UNITED STATES PATENT AND TRADEMARK OFFICE

10/530,684

Office Action Summary	Application No. 10/530,684	Applicant(s) MAYER ET AL.	
	Examiner MICHAEL R. BALLINGER	Art Unit 3732

DETAILED ACTION

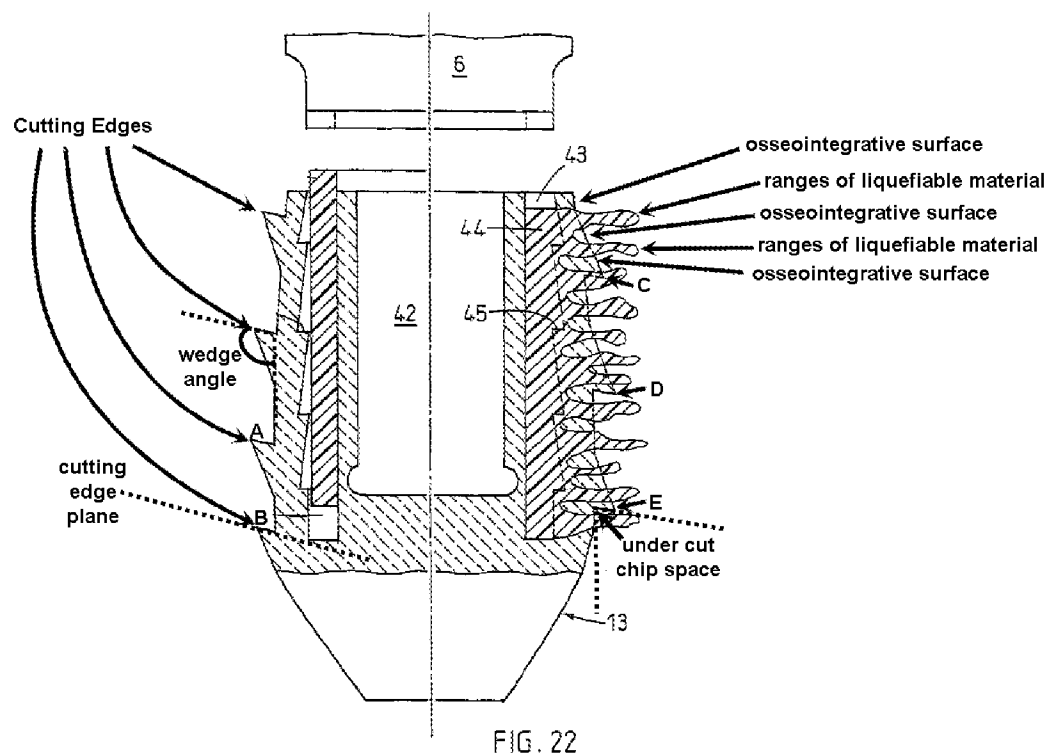
11. Per claims 2-4, Aeschlimann teaches the cutting edges have a wedge angle of less than 90 degrees (i.e. cutting edges on the right side of figure 22), are salient (i.e. cutting edges on the left side of figure 22 are jetting upward) and are under cut to form a chip space (as illustrated below).

13. Per claim 8, figure 22 teaches osseointegrative surfaces are situated between the surface ranges of the liquefiable material (as illustrated below).

16. Per claim 14 and 15, figure 22 of Aeschlimann teaches the implant including steps with cutting edges, the steps having edges with wedge angles of 90 degrees or more (as illustrated below). Also, per claim 16, Aeschlimann teaches the implant has an essentially cylindrical form and cutting edges protruding from the implant and being distanced from the implant axis by distances which decrease in the direction of the implantation (i.e. cutting edge A is further from the implant axis than cutting edge B as illustrated below).

17. Per claim 17 figure 22 of Aeschlimann illustrates the cutting edges are aligned in series in the axial direction (i.e. cutting edges C-D-E as illustrated below). Furthermore, per claim 18,

figure 22 teaches two series of cutting edges (i.e. C-D-E as illustrated below) facing each other, and surface ranges of liquefiable material are situated between the series on the implant structure (illustrated below).
